1 Products affected

2 Type of change

3 Detailed description of change

Current product rating	New product rating
UL max. 8A (E72928)	UL max. 10A (E495089)
Current product label	New product label

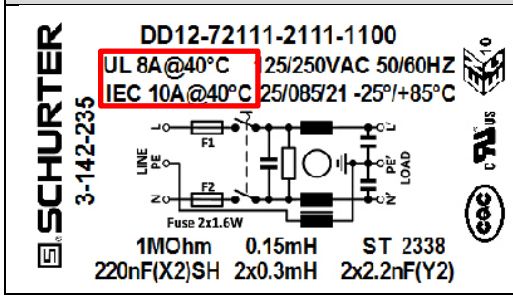
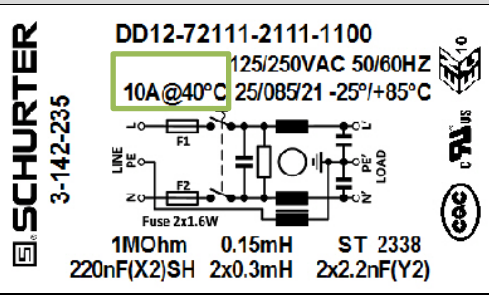
Update of approval from 8A to 10A for UL

☐	Form	
☐	Fit	
☒	Function	Product is now UL-certified for 10A instead of 8A
☐	Manufacturing	
☒	Label	UL approval for 10A instead of 8A
☐	Packaging
